ADDENDUM NUMBER ONE (1) TO THE PLANS AND SPECIFICATIONS FOR:

City of Port Aransas Public Safety Center Port Aransas, Texas Project No. 18.22

ADDENDUM

DATE: May 31, 2023

CE4.01

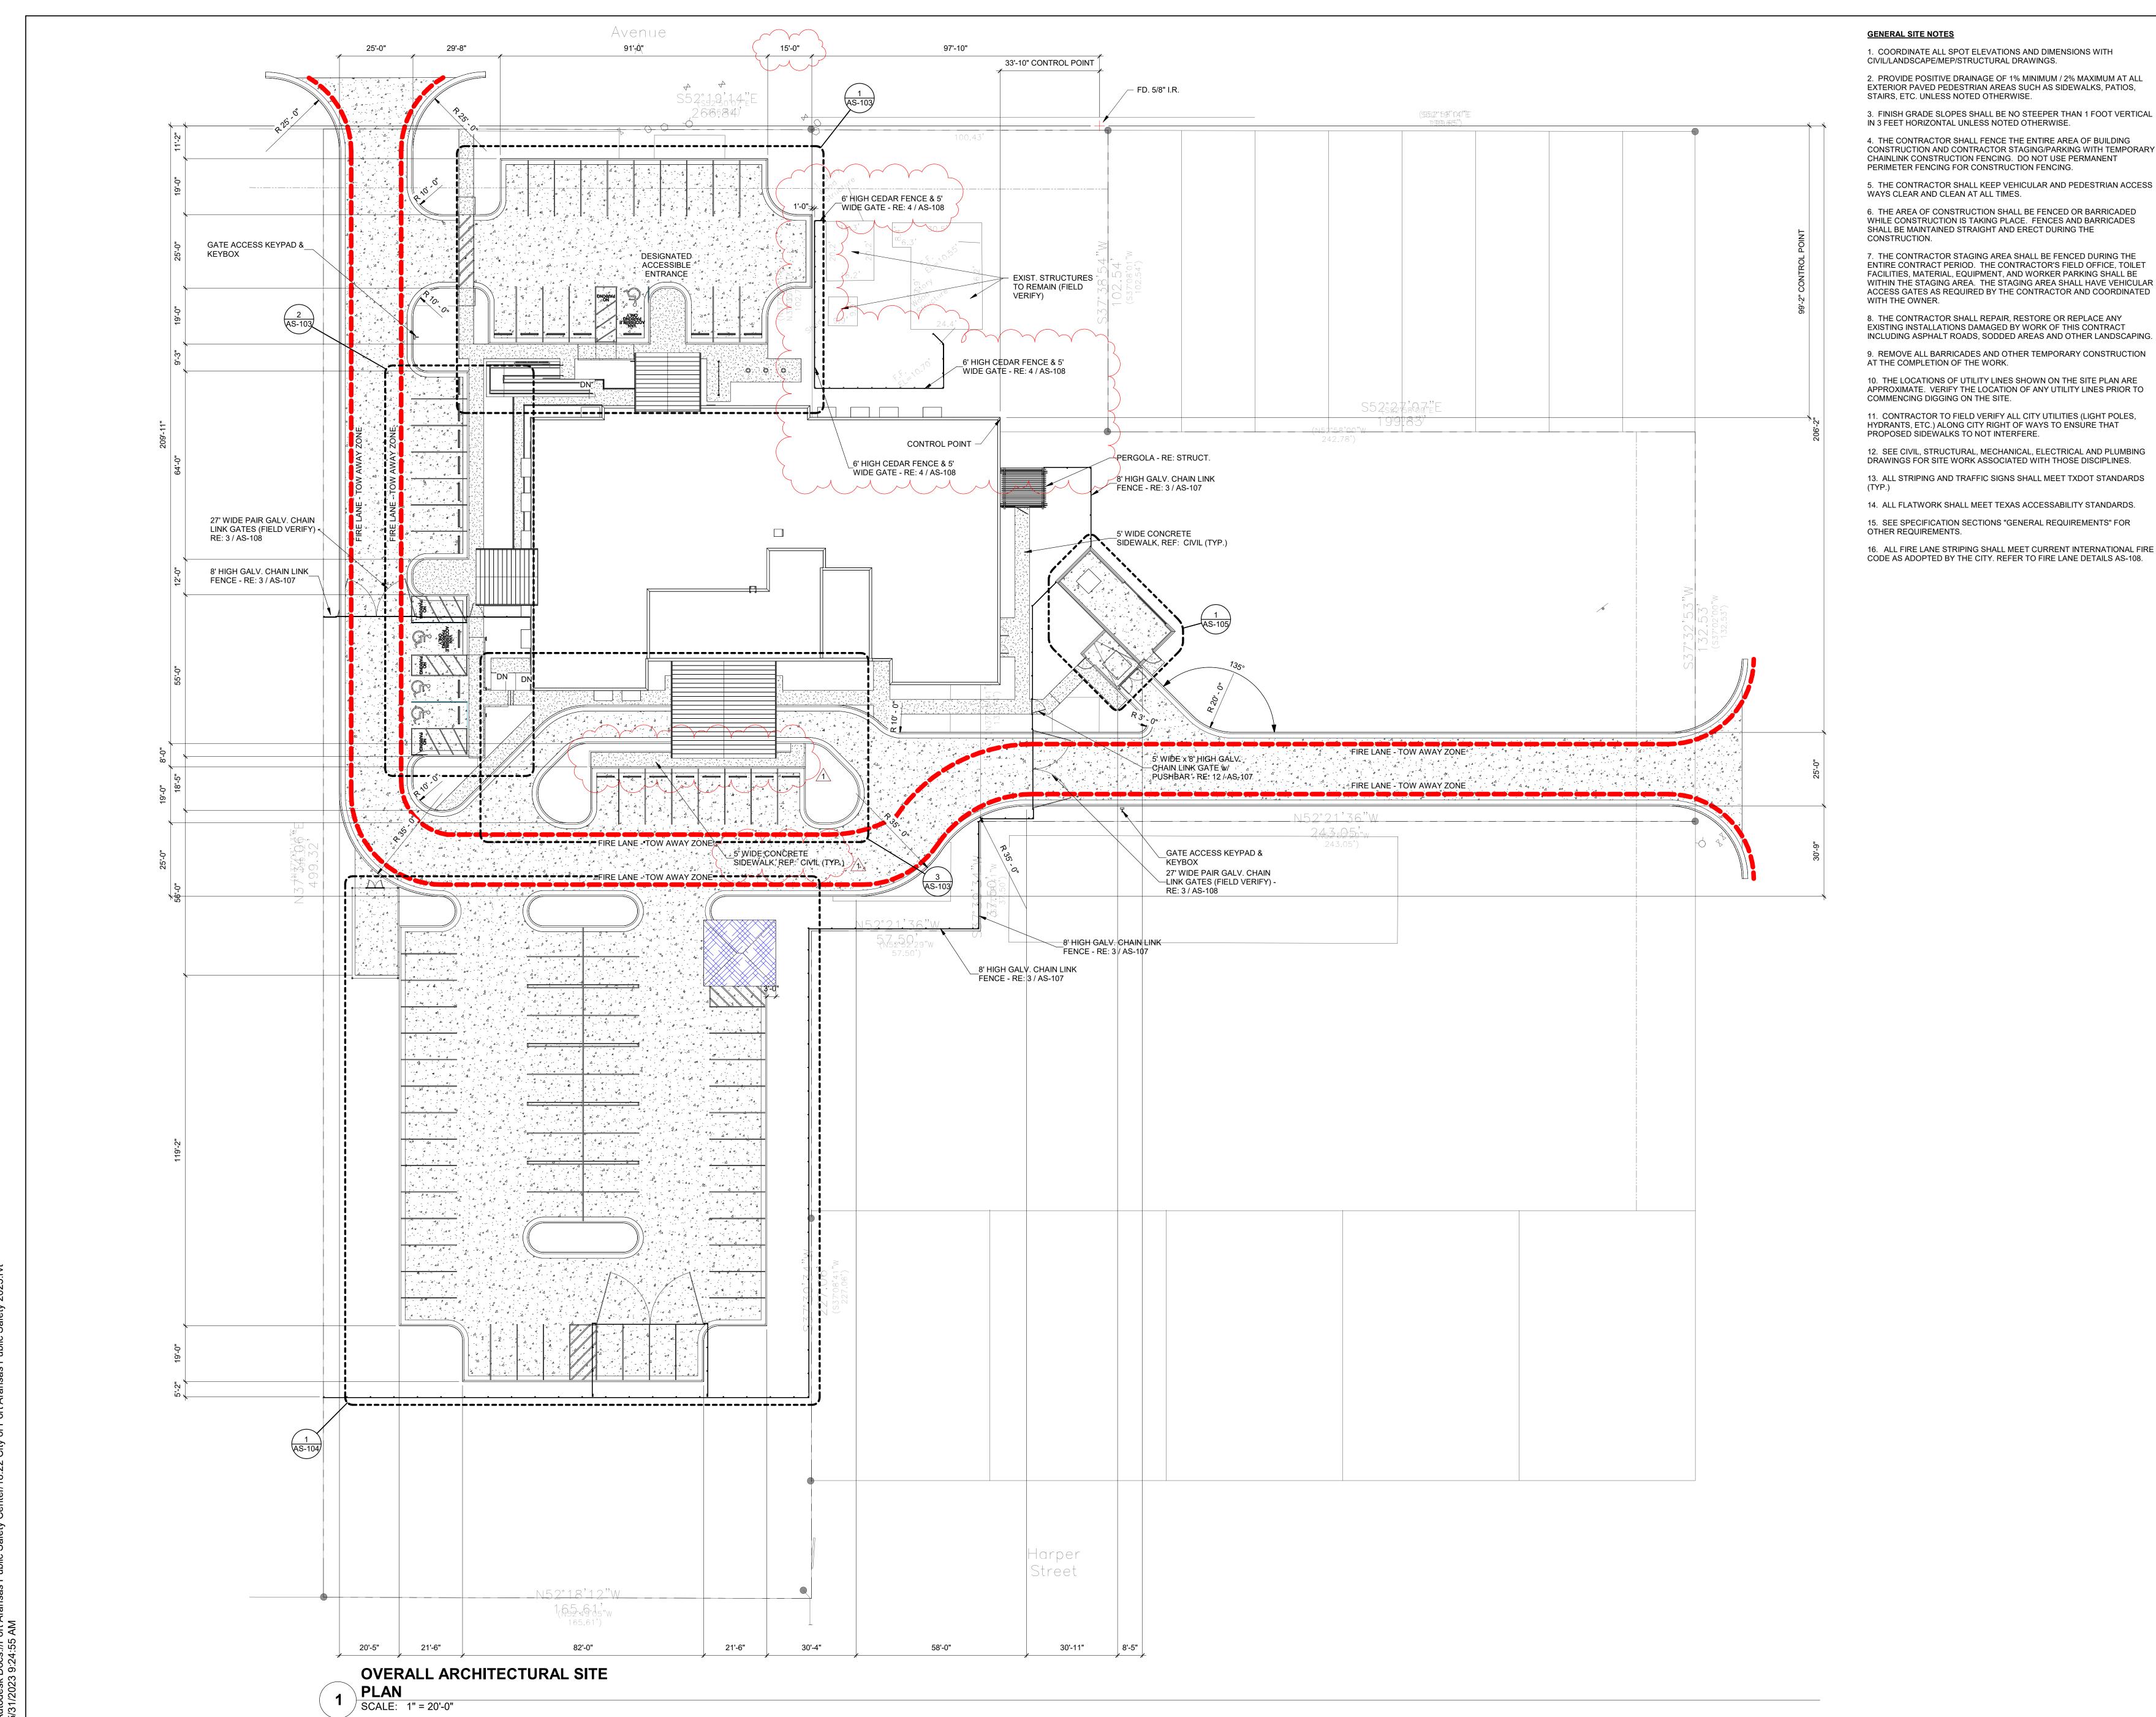
- Delete this sheet in its entirety and replace with sheet G-001, included within this addendum.
- 2. Sheet CE4.01 added.

OVERALL ARCHITECTURAL SITE PLAN

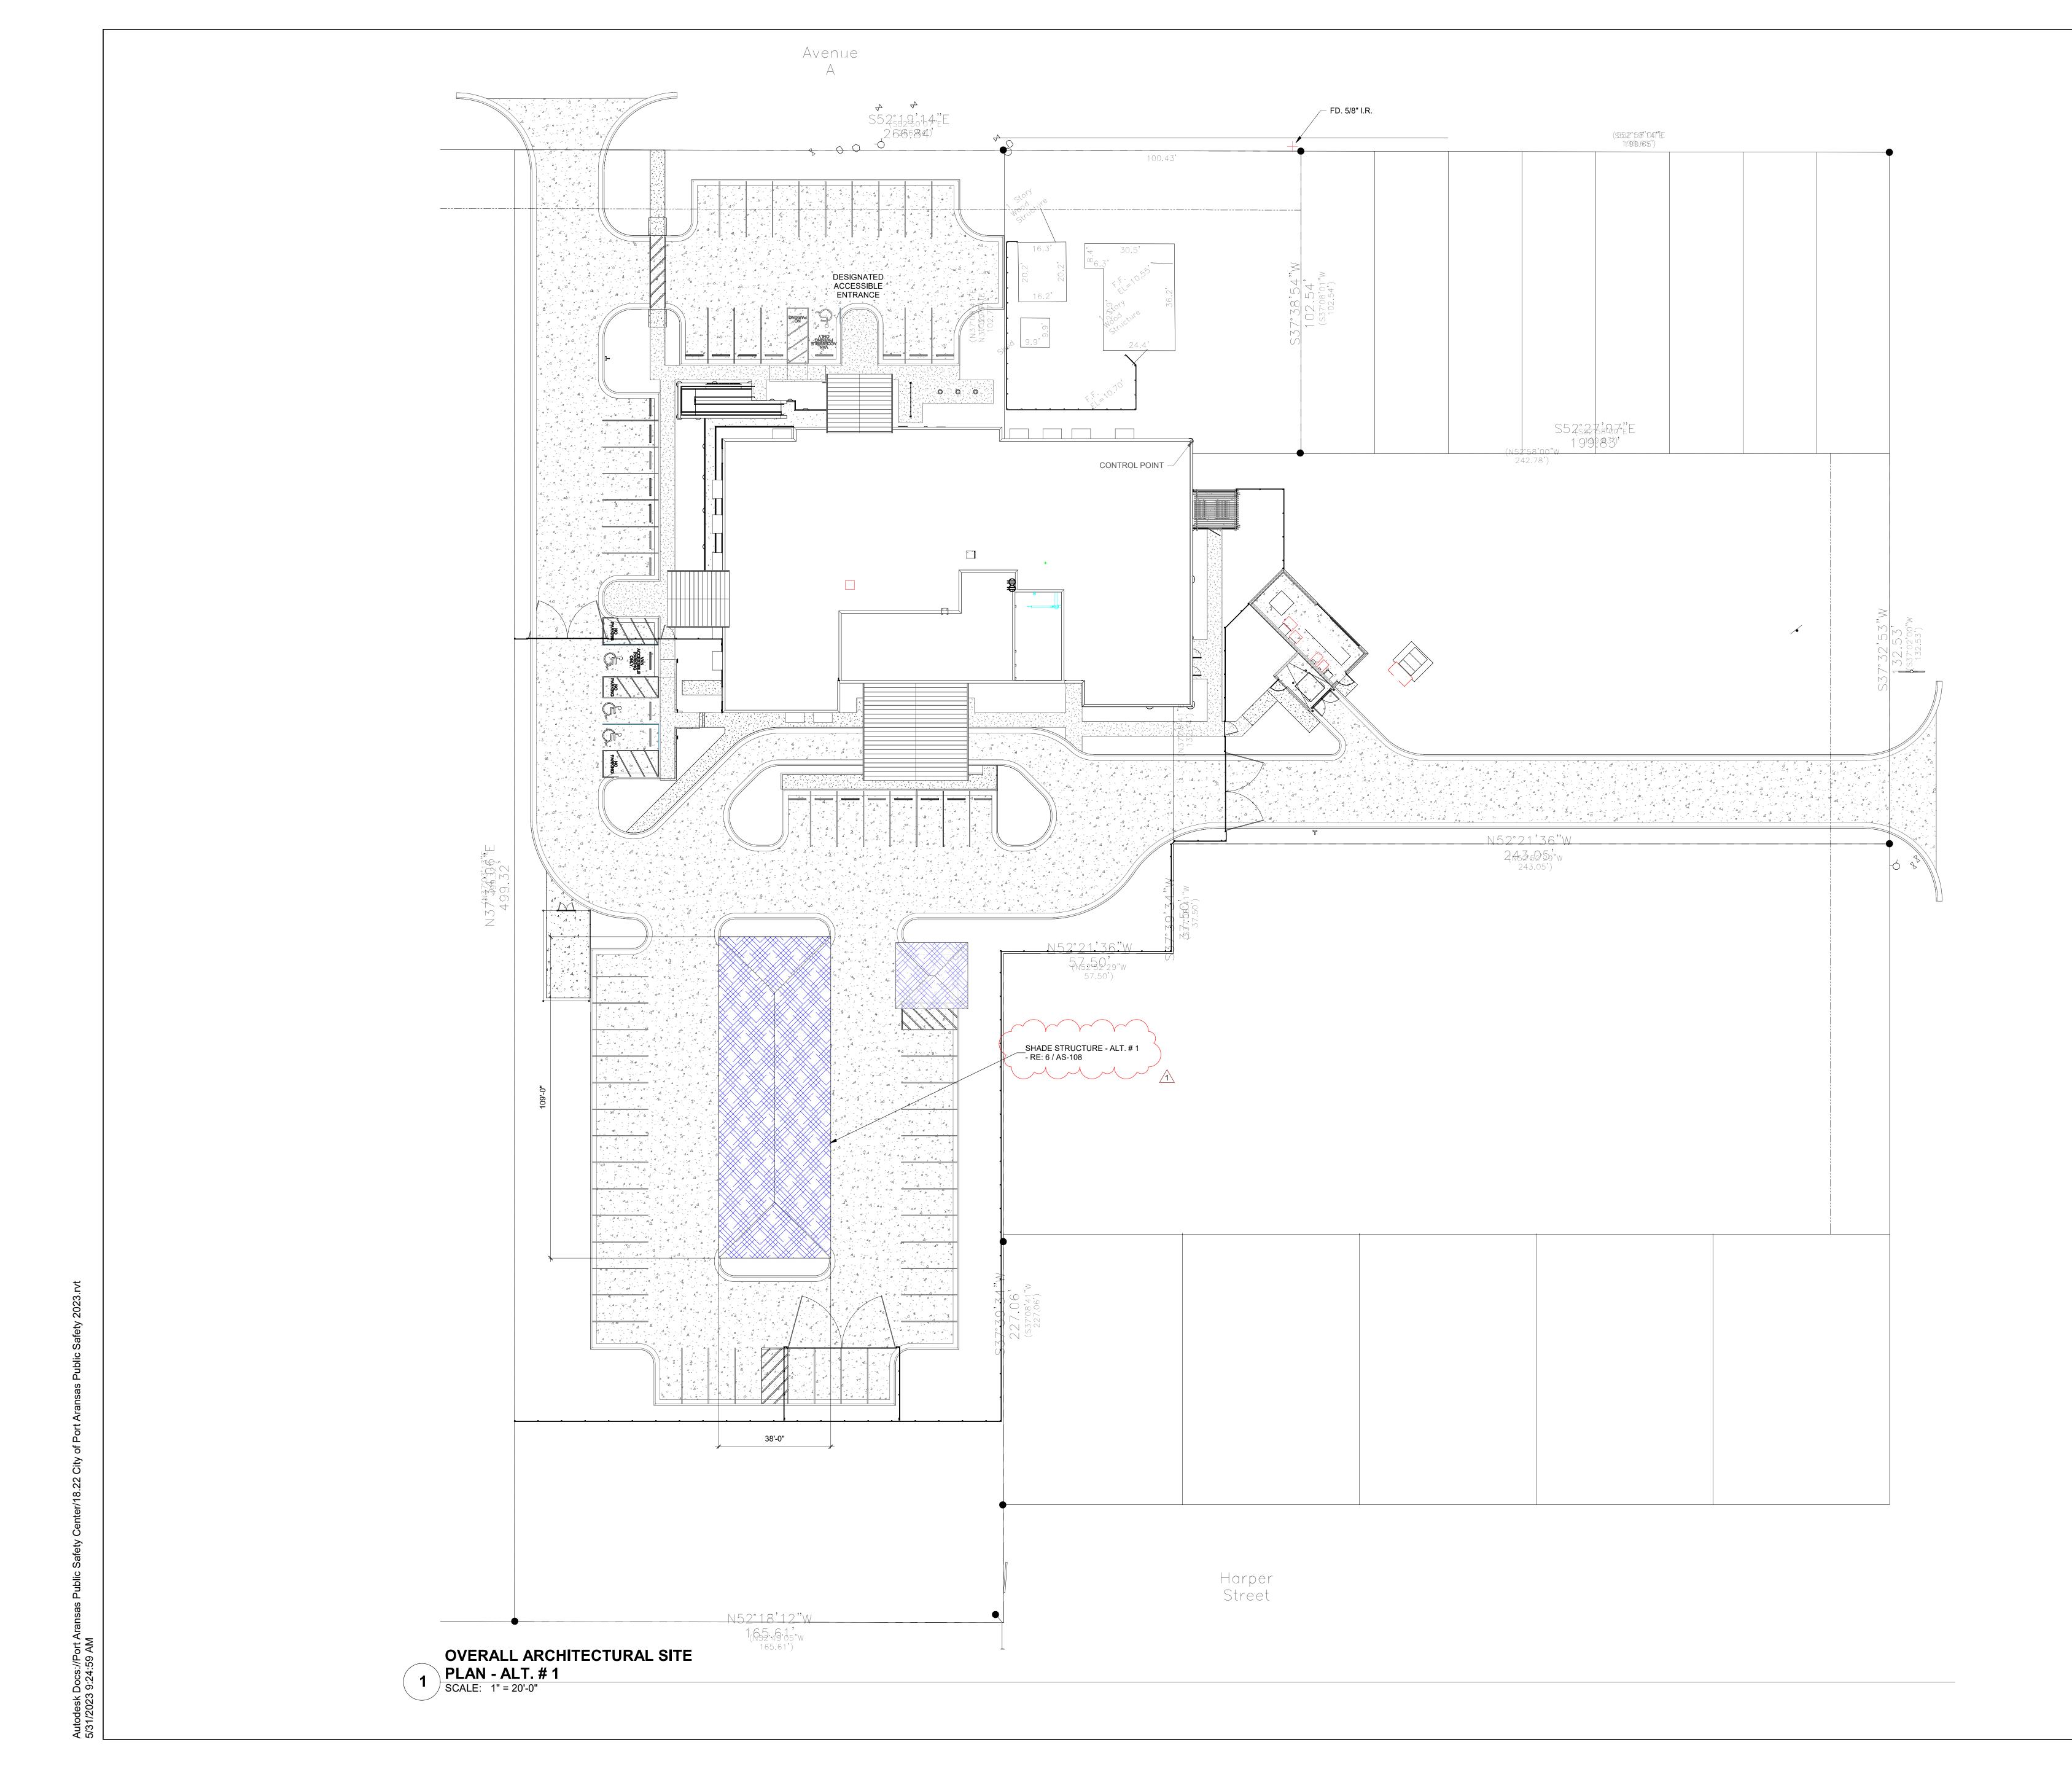
- 1. Delete this sheet in its entirety and replace with sheet AS-101, included within this addendum.
- 2. Parking lot revision.
- 3. Added fence & gate.
- 4. Added flatwork @ drop-off.
